Design Review Board Case #2018-0001
Carlyle Plaza Two – South Residential Building

The applicant, Alder Branch Realty Limited Partnership, LLLP; represented by JM Zell Partners, is requesting the Design Review Board’s (DRB) review and commentary on the revised design of the low-rise liner units proposed with the first phase of the Carlyle Plaza Two development.

Figure 6 – Low Rise Building Elevation

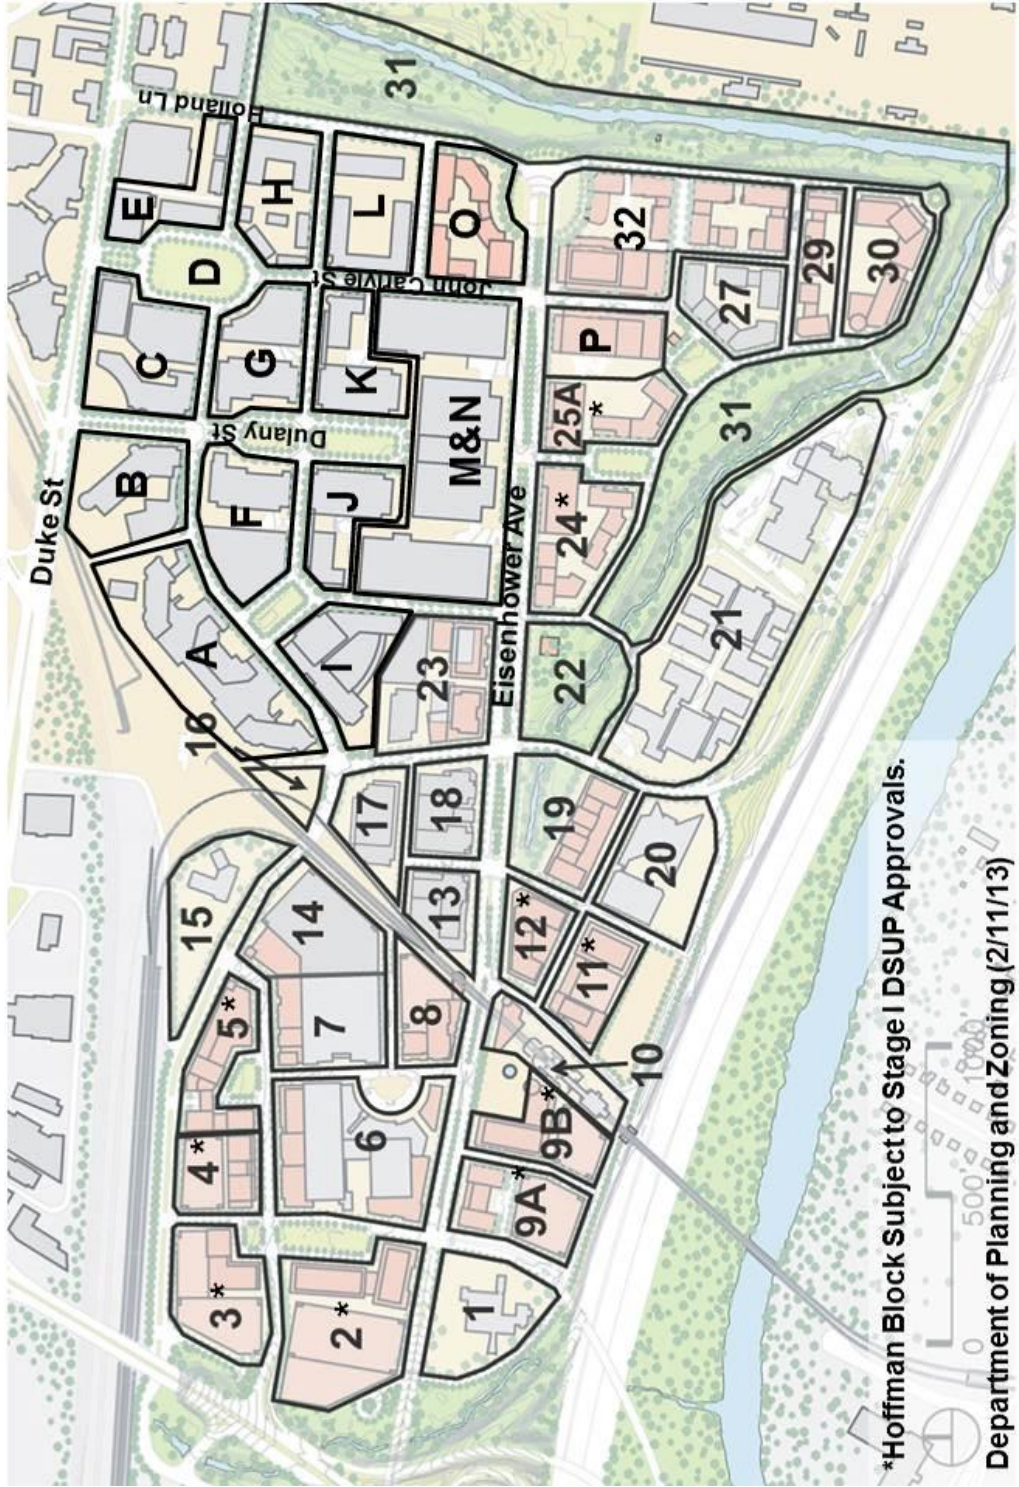
The primary, west-facing, façade of the low-rise liner units is comprised of two planes defined by an offset between the face of the building materials. The front plane forms a series of steps that cascade across this façade providing both horizontal and vertical movement that relates to the cascading effect of the glazing pattern proposed on the South Residential Tower (see Figure 6).
